ROUTT COUNTY REGIONAL BUILDING DEPARTMENT
136 Sixth Street * PO Box 773840 * Steamboat Springs, CO 80477 * (970) 870-5566 * FAX
(970) 870-5489

PLAN REVIEW COMMENTS

Job Address: 30385 Blacktail Ln. Plan Log No. ☒-07-274
Applicant: Harold Gardner & Mailyln Fiske Designer: Jakes

Design information:
Occupancy Classification: R-3
Character and Use: Add SFR
Type of Construction: VB
Number of Stories: 2

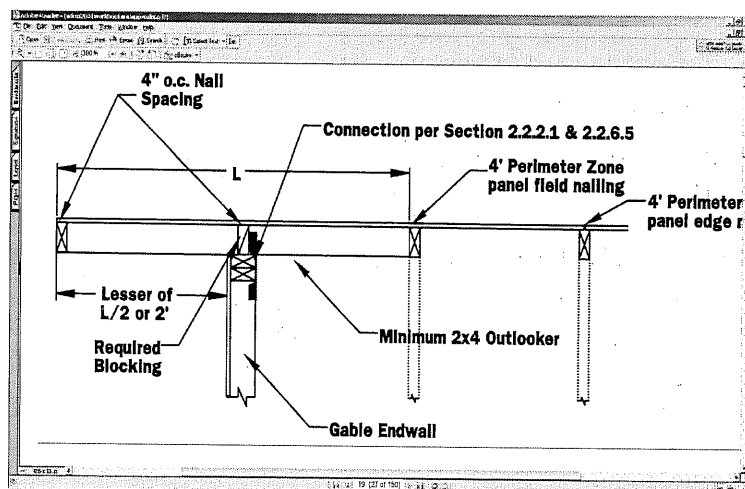
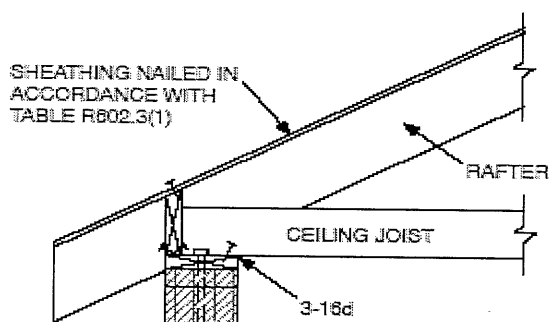
10. Unless detailed otherwise, wood structural panel sheathing shall be attached to framing in accordance with Table R602.3(1) including footnote i, which states "...spacing of fasteners on roof sheathing panel edges applies to panel edges supported by framing members and at all roof plane perimeters...Floor and roof perimeter shall be supported by framing members or solid blocking". See examples below from the IRC and the Wood Frame Construction Manual:
